Technical Bulletin

Product: A/V Receivers
Hardware Technical Bulletin: T773-H2004-03

Date: June 15, 2004 Subject: Flat Ribbon Cables

Figure 1

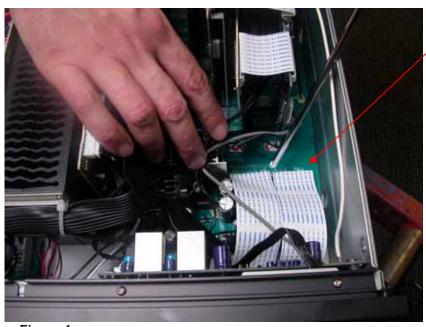
Locate and remove the ribbon cables, front panel cables shown.

SOLUTION: Clean all ribbon connectors using an eraser or preferably a non alcohol based cleaner which will leave no residue. See figures 1, 2 and 3.

Figure 2

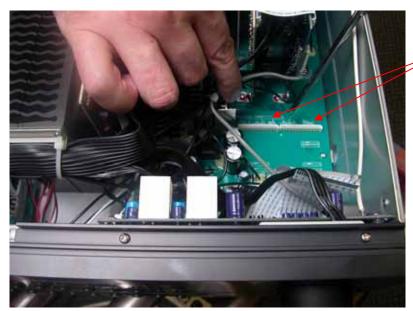
Ribbon cables are easily unplugged from these connectors.

Figure 3

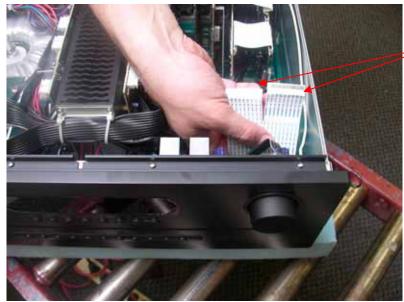
Clean the ends of the ribbon cables with eraser or non alcohol based cleaners.
